SERVICE BULLETIN

N° **189-292**

ATA 34 - GLONASS IN REAR KIT INSTALLATION

This Service Bulletin is issued in order to provide the necessary instruction on how to perform the installation of “GLONASS in rear kit” P/N 8G3450F01511.

Figure 1

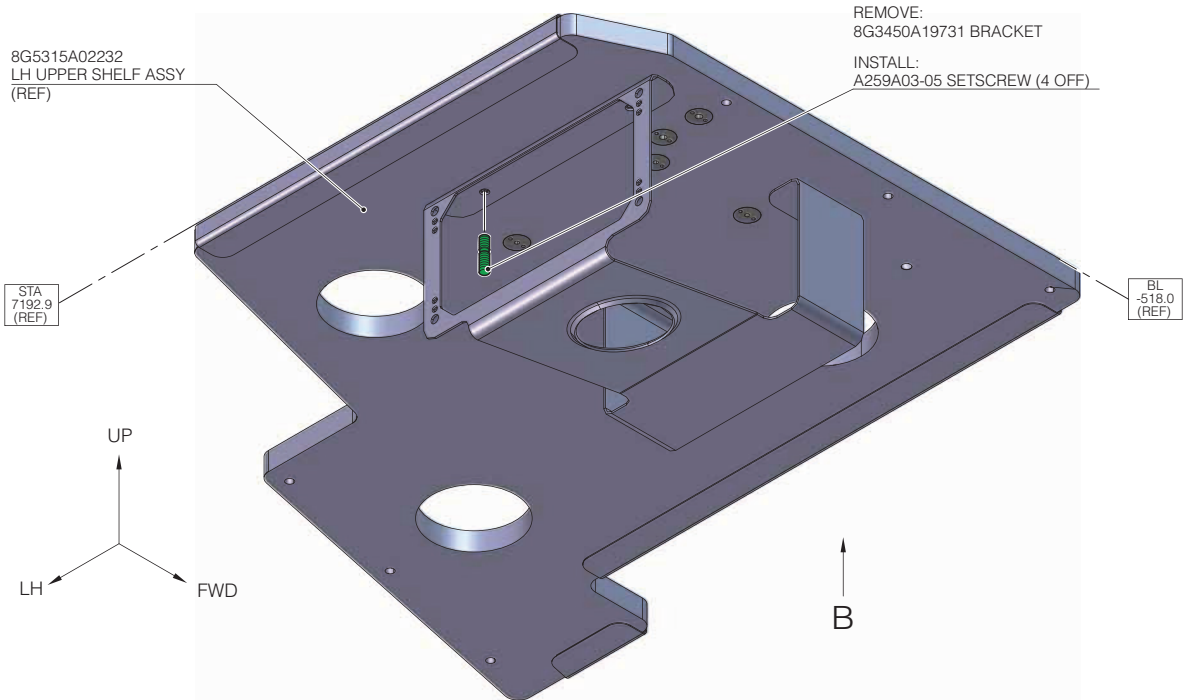
2. In accordance with AMP DM 89-A-06-40-00-00A-028A-A, remove access panel 165B to get access to the rear LH avionic bay.
 3. With reference to Figures 1 and 2, perform GLONASS rear structural provision P/N 8G3450P04311 as described in the following procedure:

Figure 2

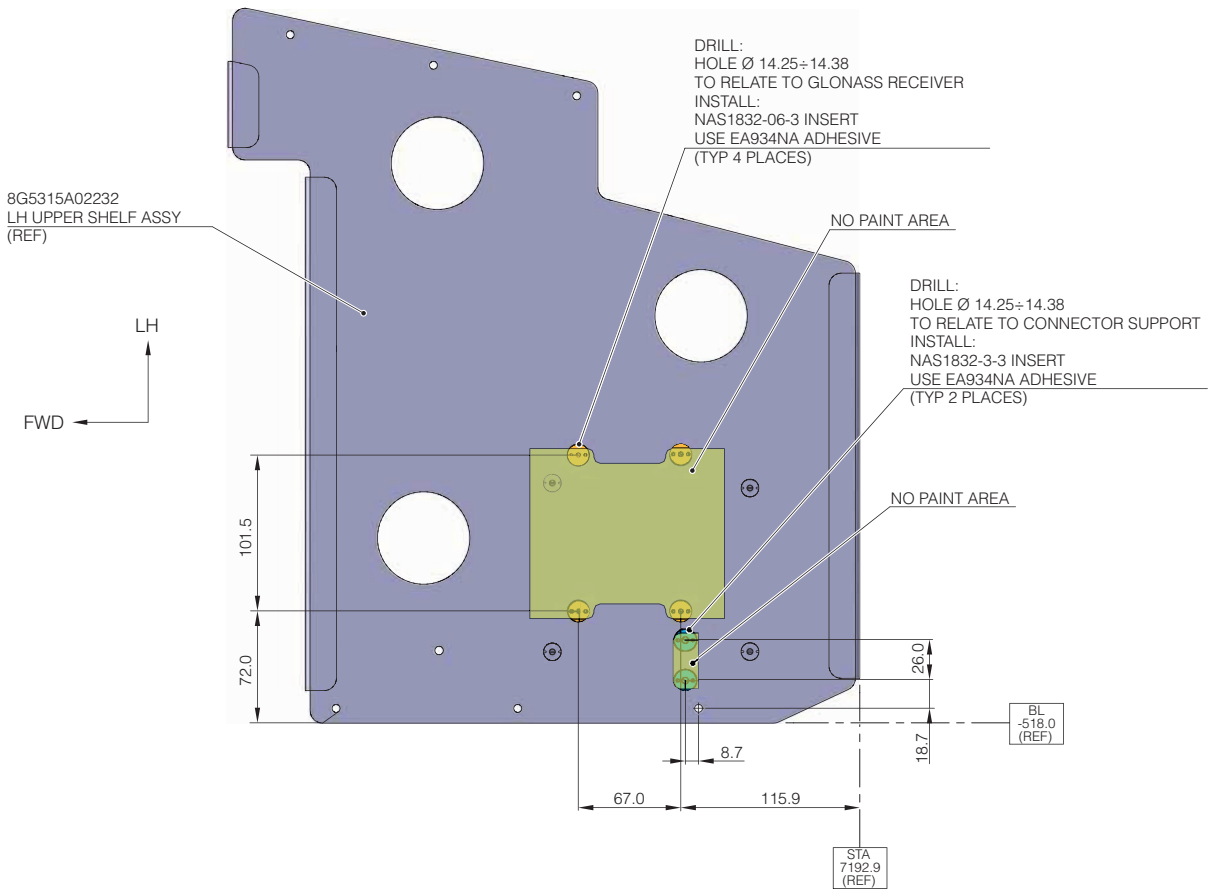
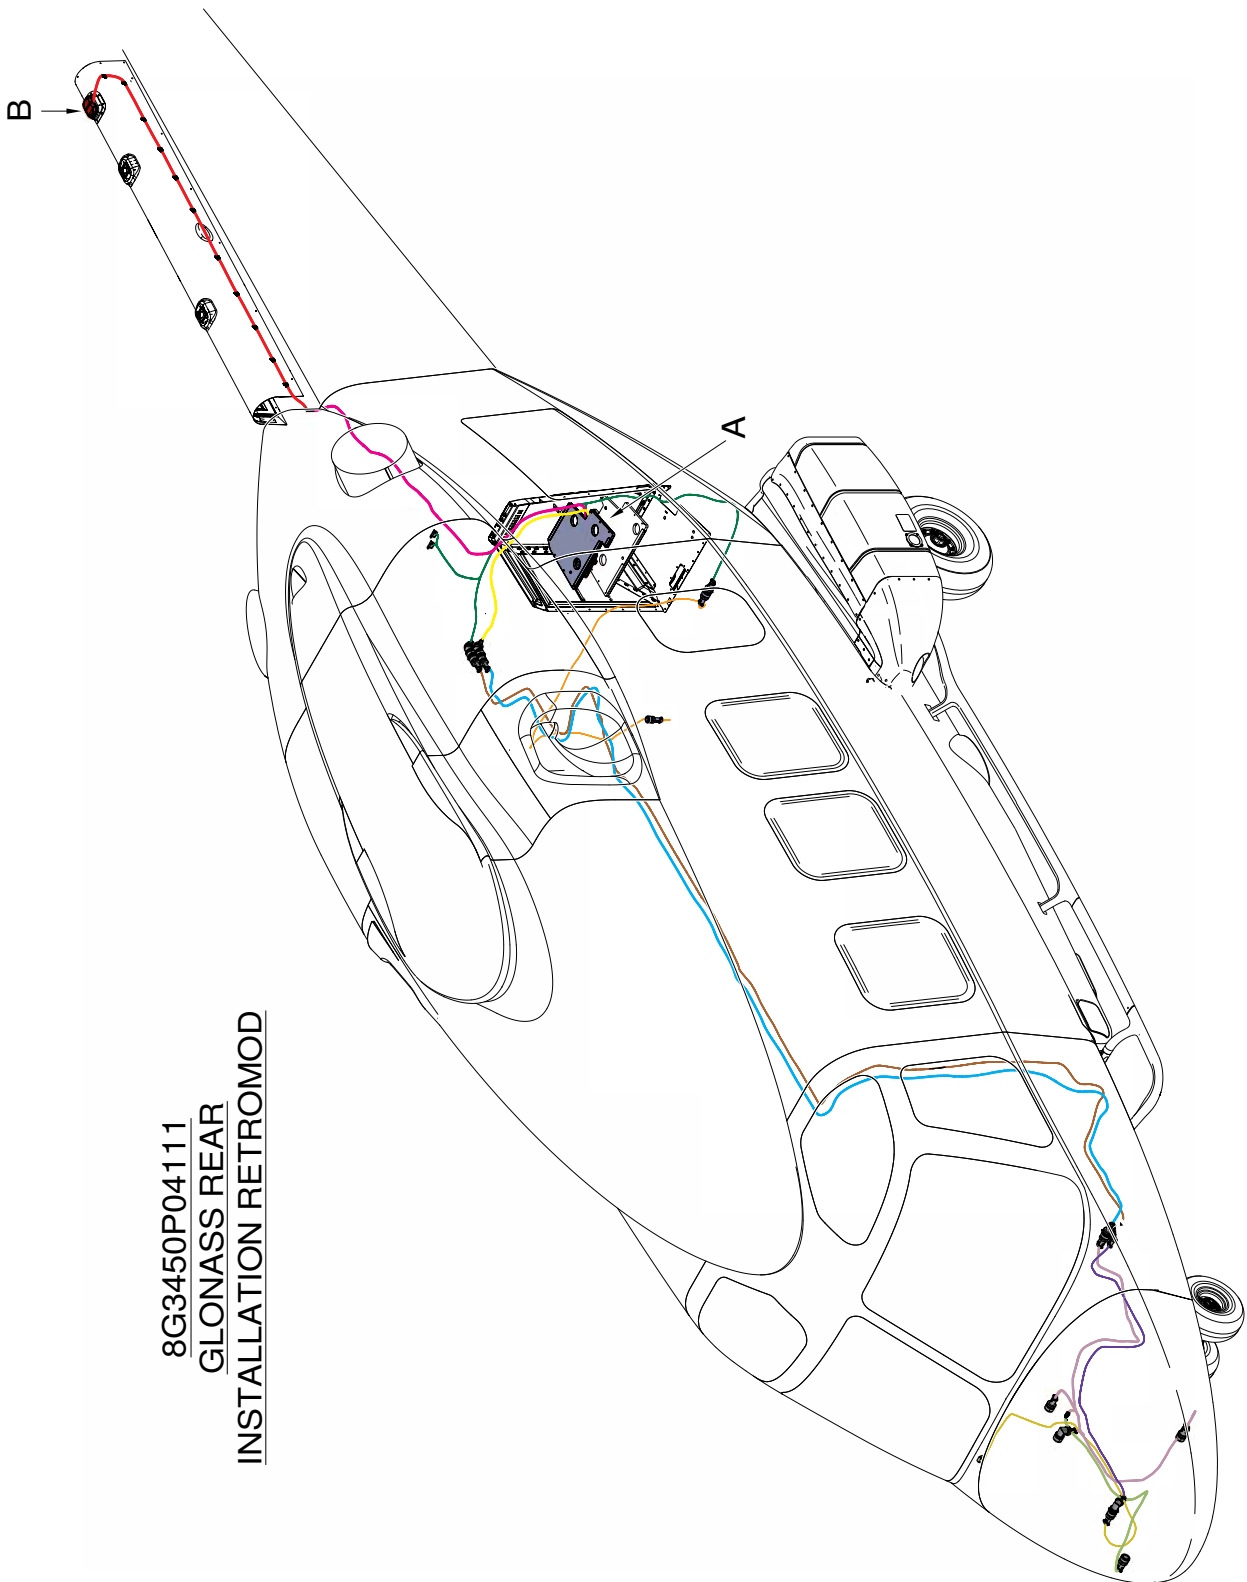
- 3.1 With reference to Figure 2 View A, remove the bracket assy P/N 8G3450A19731 from the LH upper shelf assy P/N 8G5315A02232.

- 3.2 With reference to Figure 2 View B, temporarily locate GLONASS receiver P/N ASD776-AASXYZ and mark position of n°4 insert holes at positions shown.

- 3.1 With reference to Figure 2 View B, drill n°4 insert holes Ø14.25÷14.38 at the previously countermarked positions.
- 3.2 In accordance with CSRP DM CSRP-A-51-42-00-00A-720A-D and with reference to Figure 2 View B, install n°4 inserts P/N NAS1832-06-3 by means of adhesive EA934NA (C057).

- 3.3 With reference to Figure 2 View B, temporarily locate support P/N A414A03V224A1 and mark position of n°2 insert holes at positions shown.
- 3.4 With reference to Figure 2 View B, drill n°2 insert holes Ø14.25÷14.38 at the previously countermarked positions.

- 3.5 In accordance with CSRP DM CSRP-A-51-42-00-00A-720A-D and with reference to Figure 2 View B, install n°2 inserts P/N NAS1832-3-3 by means of adhesive EA934NA (C057).

- 3.6 With reference to Figure 2 View A, install n°4 setscrews P/N A259A03-05 to close the unused holes.
- 3.7 With reference to Figure 2 View B and in accordance with DM CSPP-A-20-10-12-00A-259A-D, prepare the surface shown for good electrical bonding.

Figure 4

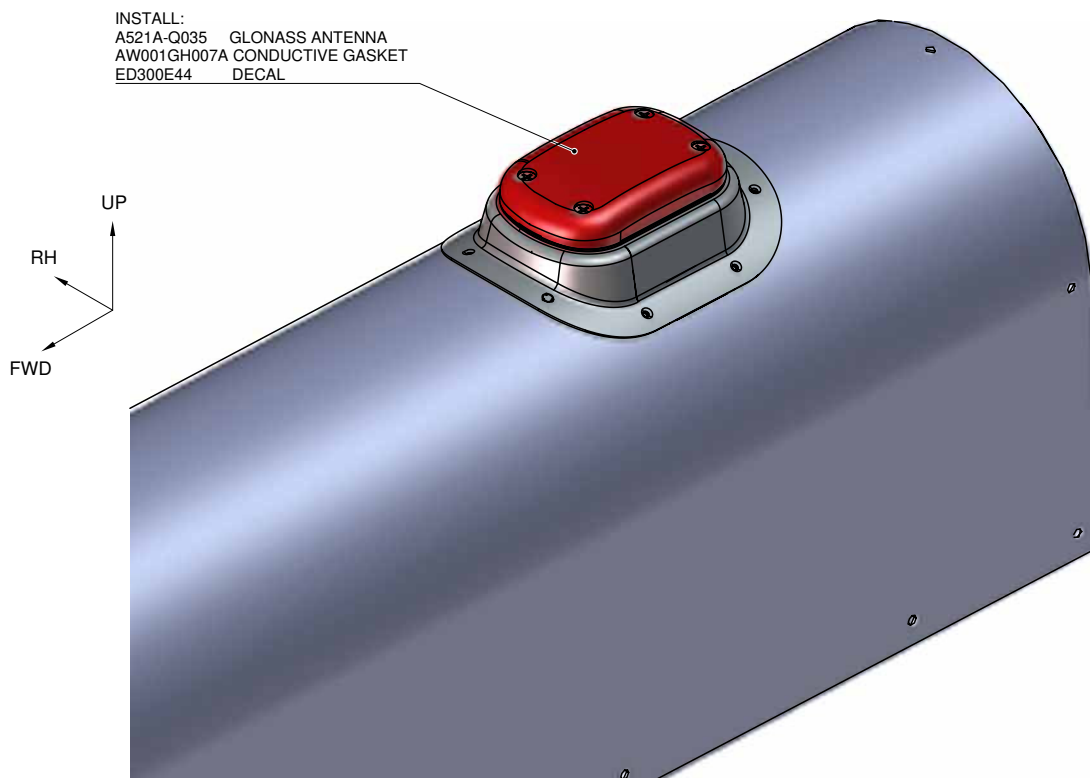
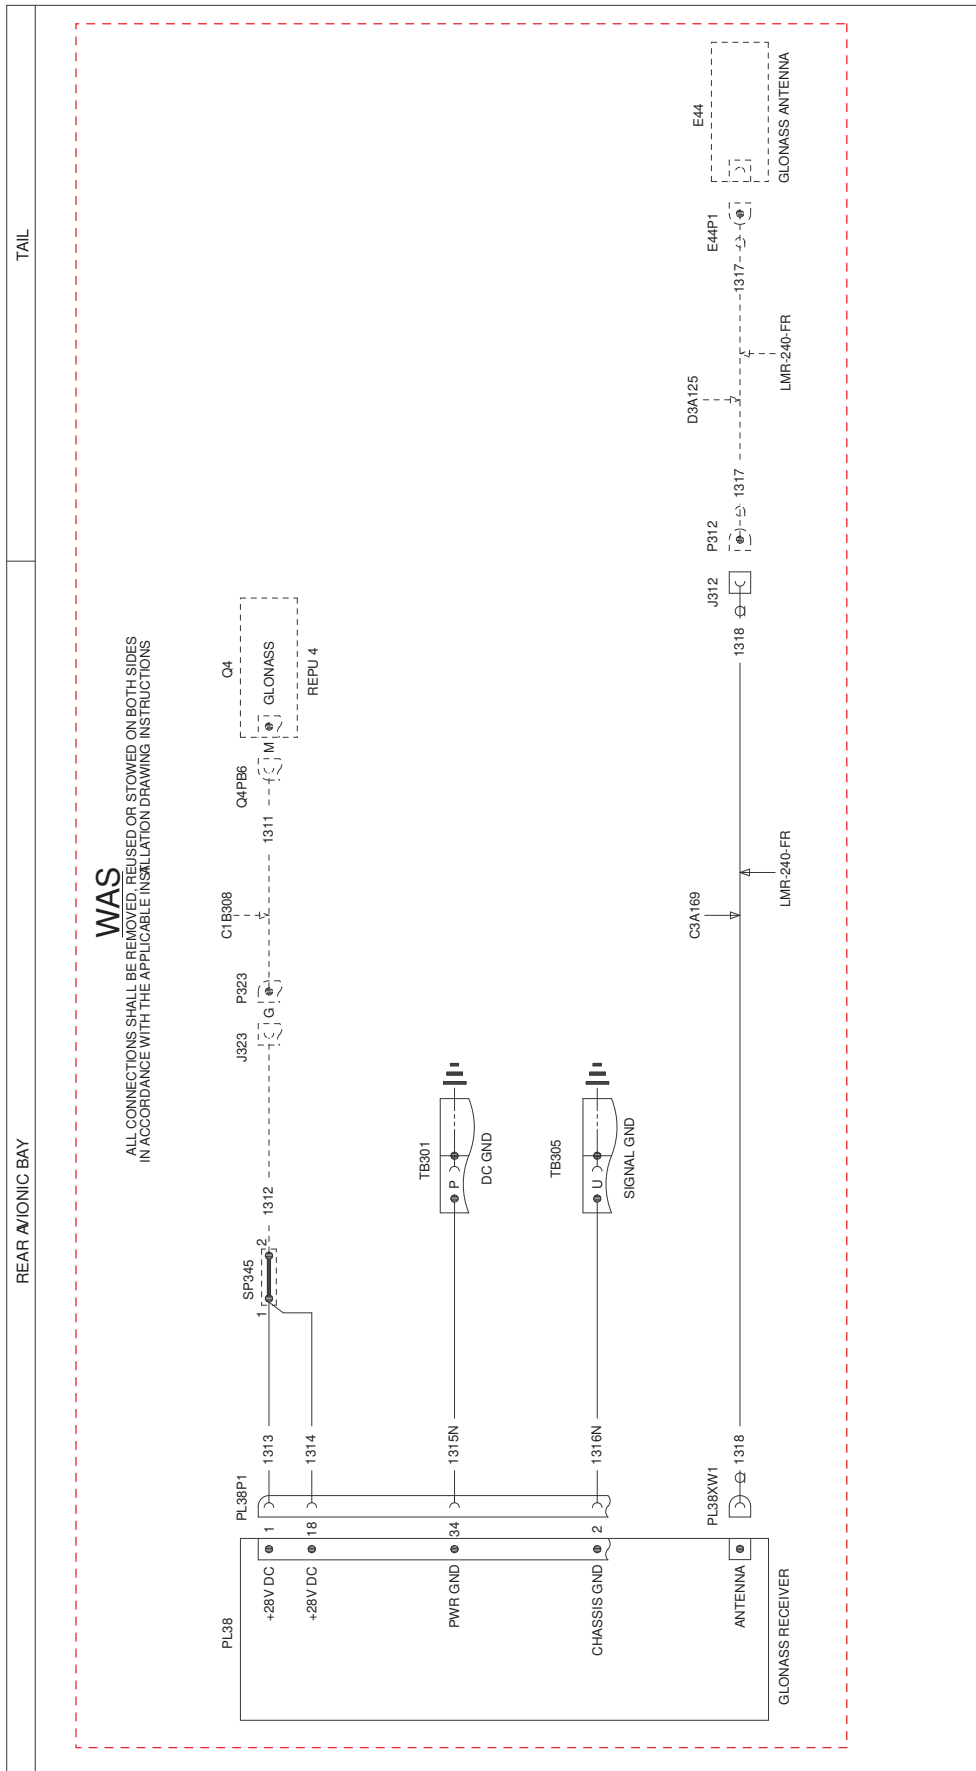
- 4.4 With reference to Figure 4 and Figure 6 wiring diagrams, remove and discard the connector PL38P1 P/N RD50S10GVL0/AA from the helicopter.
- 4.5 With reference to Figure 4 View A, install support P/N A414A03V224A1 by means of n°2 screws P/N NAS1802-3-6 and n°2 washers P/N NAS1149D0332J.

- 4.6 With reference to Figure 4 View A, assemble maintenance connector P/N 233-301XW00-175LN1 and backshell P/N A529A400-1702C. Install the new connector to the support P/N A414A03V224A1 by means of connector mounting device P/N M85049/95-18A, n°4 screws P/N NAS1802-04-7 and n°4 washers P/N NAS1149DN416J. In accordance with AMP DM 89-A-11-00-01-00A-720A-A, install decal P/N ED300J369 adjacent to the connector.

- 4.7 With reference to Figure 4 View A, assemble connector P/N CT15-26S7 and backshell P/N M85049/48-2-2F by means of n°2 screws P/N D20419-21.
- 4.8 With reference to Figure 6 and 8 wiring diagrams (BECOMES), perform the electrical connections shown to the new A361P1 connector. Install n°3 caps P/N A583A2418C on wires 1314 and 1329.

- 4.10 With reference to Figure 8 wiring diagram, install on connector A361P1 shell a terminal lug P/N MS25036-148.
- 4.11 With reference to Figure 4 View A and in accordance with AMP DM 89-C-34-56-01-00A-720A-A, install the GLONASS receiver P/N ASD776-AASAXYZ by means of n°4 screws P/N NAS1802-06-6 and n°4 washers P/N NAS1149DN632J. Connect A361P1 connector and A362P2 coaxial connector. In accordance with AMP DM 89-A-11-00-01-00A-720A-A, install decal P/N ED300A361 adjacent to the GLONASS receiver.

- 4.12 With reference to Figure 4 View B and in accordance with AMP DM 89-C-34-56-03-00A-720A-A, install the GLONASS antenna P/N A521A-Q035 and the conductive gasket P/N AW001GH007A. In accordance with AMP DM 89-A-11-00-01-00A-720A-A, install decal P/N ED300E44 adjacent to the GLONASS antenna.

Figure 5

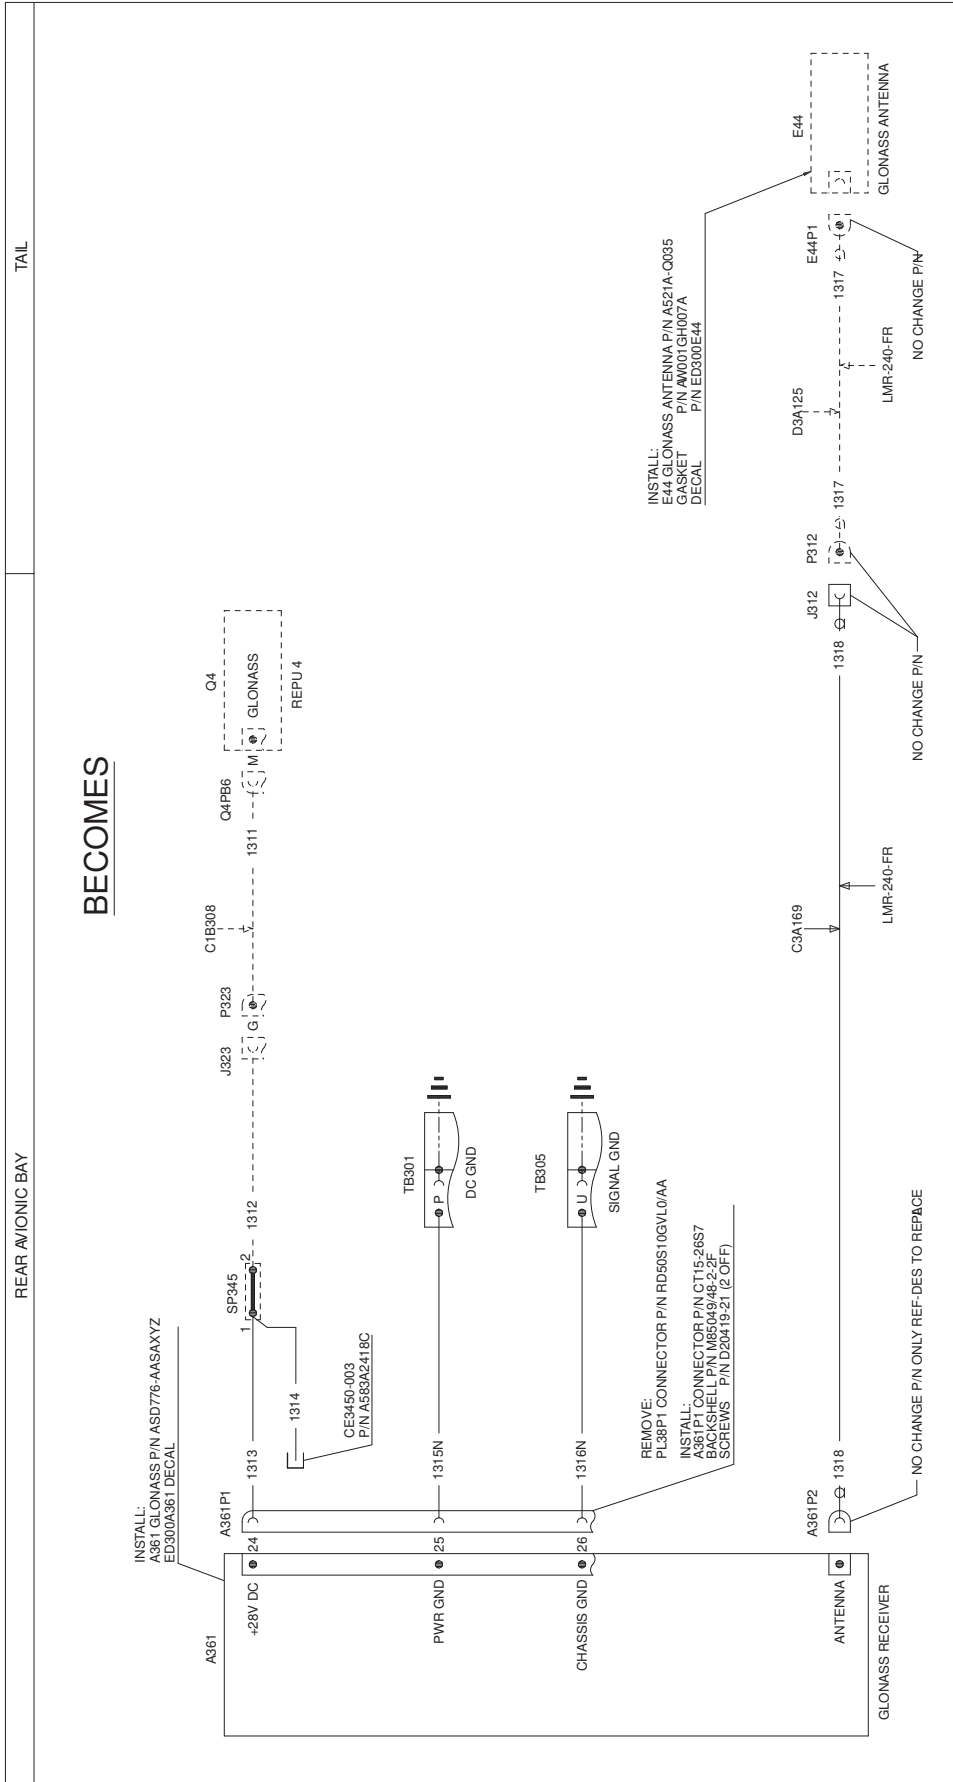
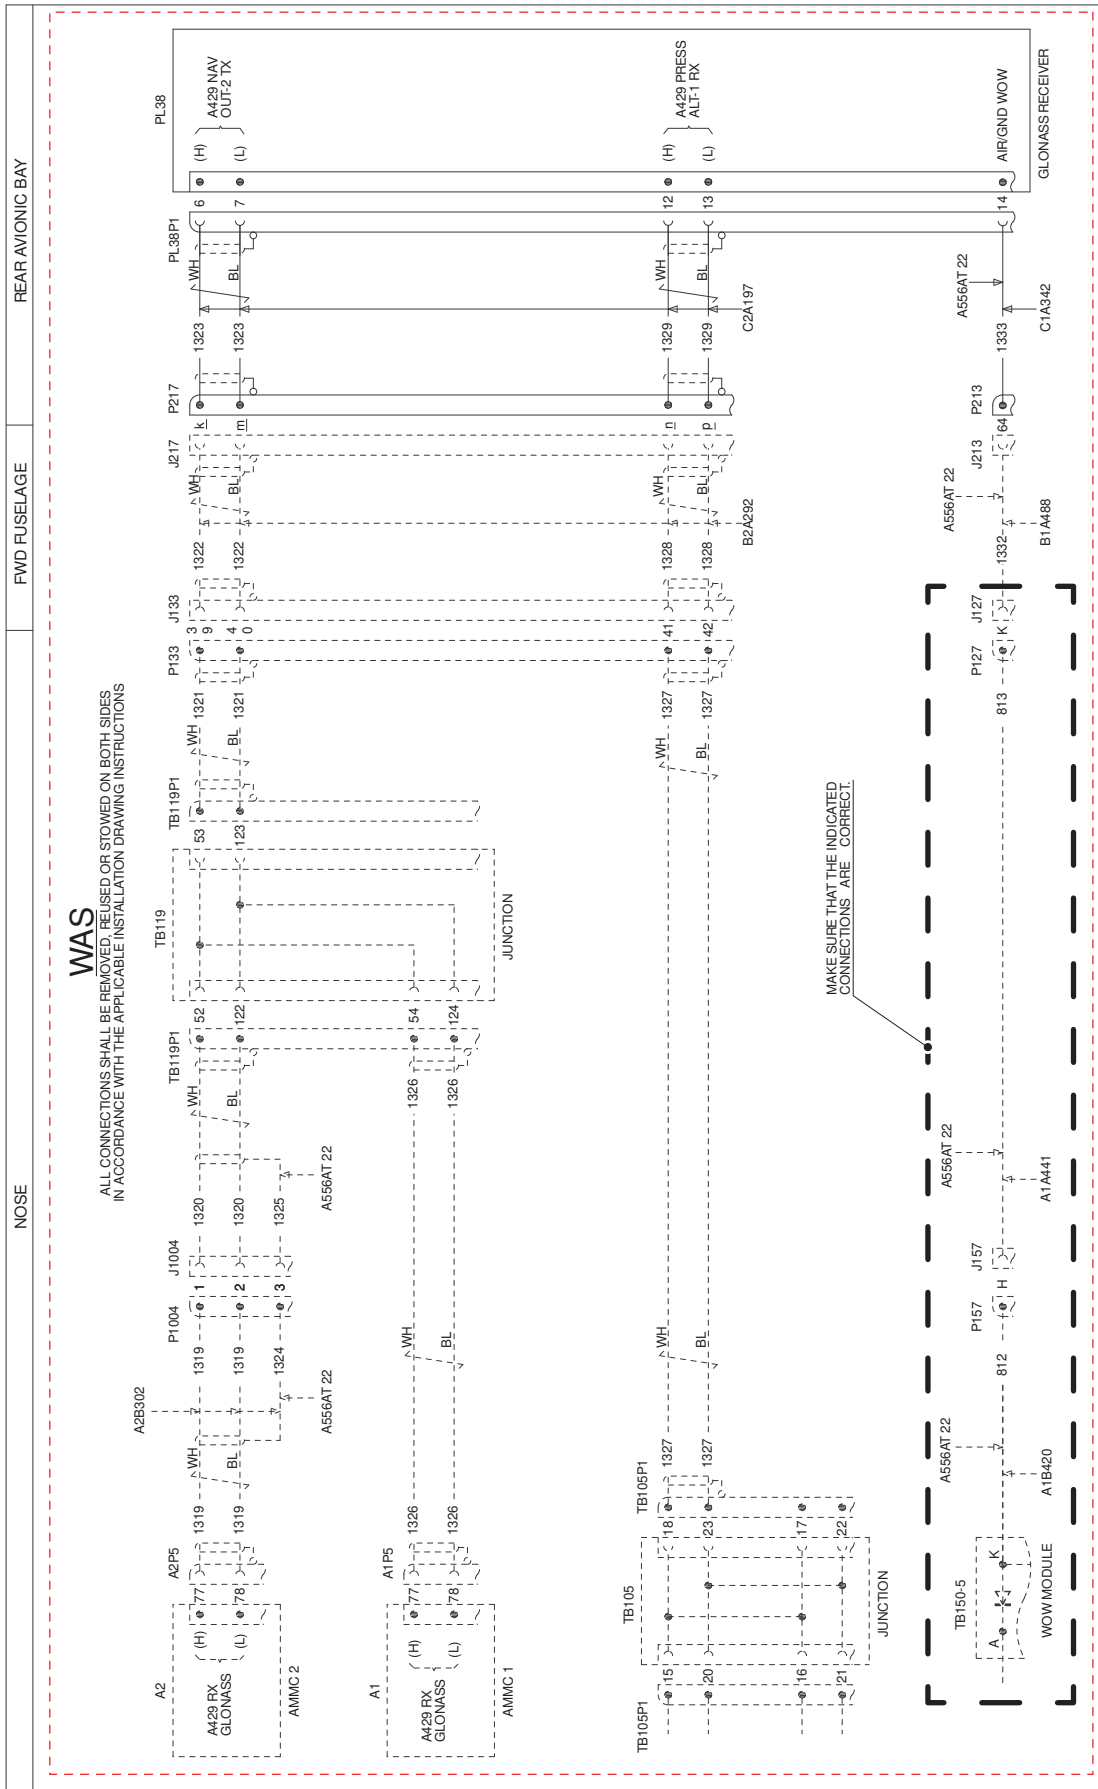
4. With reference to Figures 3 thru 8, perform GLONASS rear installation retromod P/N 8G3450P04111 as described in the following procedure:
 - 4.1 With reference to Figure 5 wiring diagram (WAS), get access to the PL38P1 connector in the LH rear avionics bay and remove the following wires:

- 1313 from pin 1 of PL38P1 connector;
 - 1314 from pin 18 of PL38P1 connector;
 - 1315N from pin 34 of PL38P1 connector;
 - 1316N from pin 2 of PL38P1 connector;
